**Environmental Impact Statement
Scoping Process**

Summary Report

**Prairie Island Nuclear Generating
Plant, Units 1 and 2
Red Wing, Minnesota**

May 2009

Figure 2.

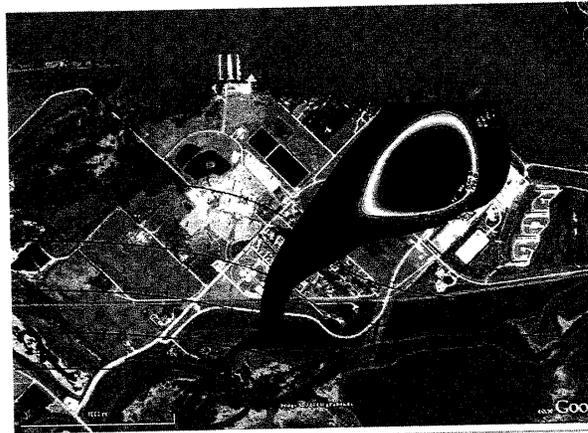
Figure 2, below, represents a simulated groundwater modeling showing the movement of tritium from the PINGP towards the Prairie Island Indian Community. The Community respectfully demands a full and complete disclosure of the monitoring data for all tritium and other radiological contaminants for each well or other monitoring location, and not simply monthly, quarterly or annual averages for individual wells. This data is critical to identify and baseline accidental and planned releases of tritium and other radiological contaminants, and to facilitate the Community's preparation of exposure scenarios, scenario analysis, and computer modeling of all environmental pathways for tritium contamination.

- The higher tritium concentration in onsite wells indicate that PINGP is the tritium source of PIIC wells (see Figure 2);
- No explanation was provided for off-site residence well contamination of tritium since 1989;
